No.: Radio 83 Origin: Radio Engineering

# TECHNICAL DATA SHEET

# CHASSIS TYPES T2, O3 AND U2.

# PRODUCTION CHANGE — CHASSIS TYPES T2, 03 AND U2

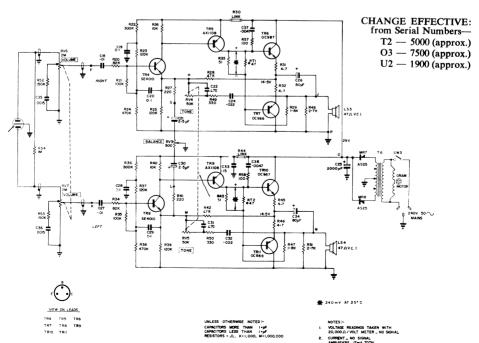
A change has been made in production receivers of the complementary symmetry output transistor pair Types AX1103, AX1104 and associated biasing network (270 ohms. resistor and two AB1102 diodes). The transistors are being replaced by a pair of germanium transistors complete with cooling fins, Type OC987 and OC988 (E.M.I. Part Number for this pair is 932-2991), replace AX1103 and AX1104, respectively. A 47 ohms. thermistor (E.M.I. Part Number 752-0111) shunted by a 51 ohms. resistor (E.M.I. Part Number 740-1841) is used to replace the previous bias network.

A Circuit Diagram for the revised circuit section is shown on this Data Sheet.

By using the uncut pigtails of the OC987 and OC988, appropriately sleeved and soldered to the printed circuit board to permit maximum pigtail length, it is possible to mount the cooling fins supplied with these transistors on the same mounting centres as the original cooling fins.

In the case of the U2 chassis, the output transistors are mounted in a similar manner to the existing JC and JF chassis. For T2 and O3 chassis, the following mounting method is

Loosen the upper board retaining bushes by rotating them. The cooling fins may now be wedged between the bushes and the chassis front plate. By tilting the cooling fins in such a manner that all four pins form a "W"-with the bottom of the fin touching the bushes, the output transistors may be mounted on top of each fin.
